Main Design Flaws:

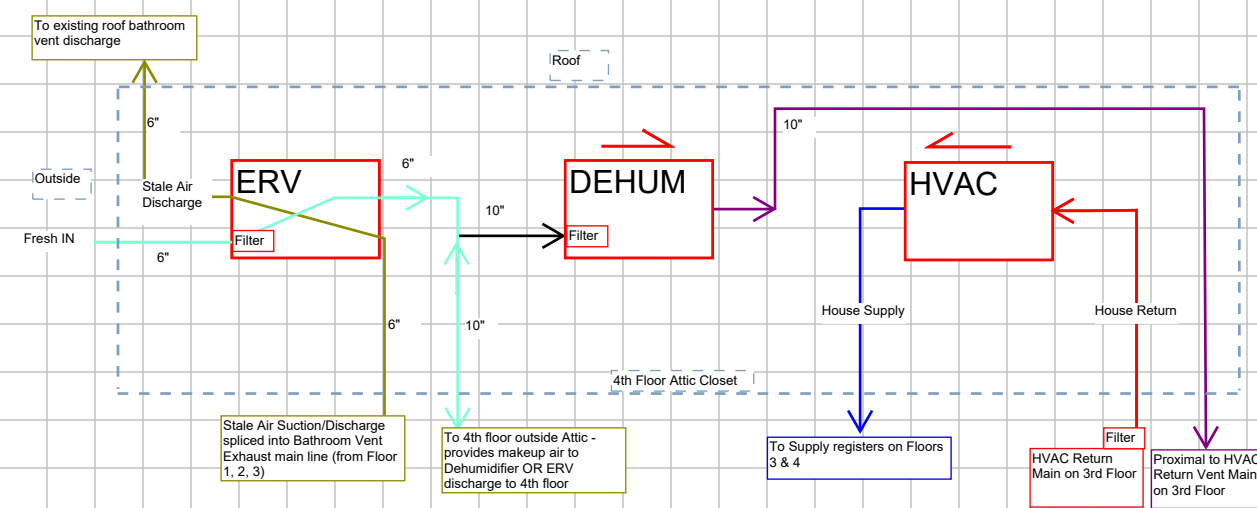
1. Exhaust Only Ventilation. If bathroom vents or range hood is not running, house is not ventilating.
2. No dedicated Dehumidifier
